Access Compliance Report Public Rights-of-Way (Pedestrian Signals)

Main Street: LA_LOMA_DR Cross Street: NEWPORT_AVE Location: NE

ADA ID: SGRK211008142216 Signal Type: One Push Button-APS Overall Compliance: No Severity Scores: BTN 1: 25 BTN 2: N/A No BTN: N/A

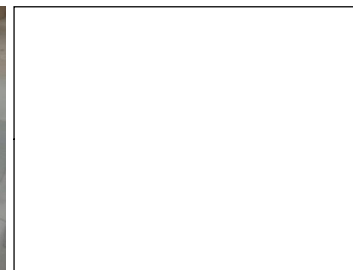
OC Std/PROW: R404.2, R404.3

Possible Solutions: Remove and Replace Clear Space.
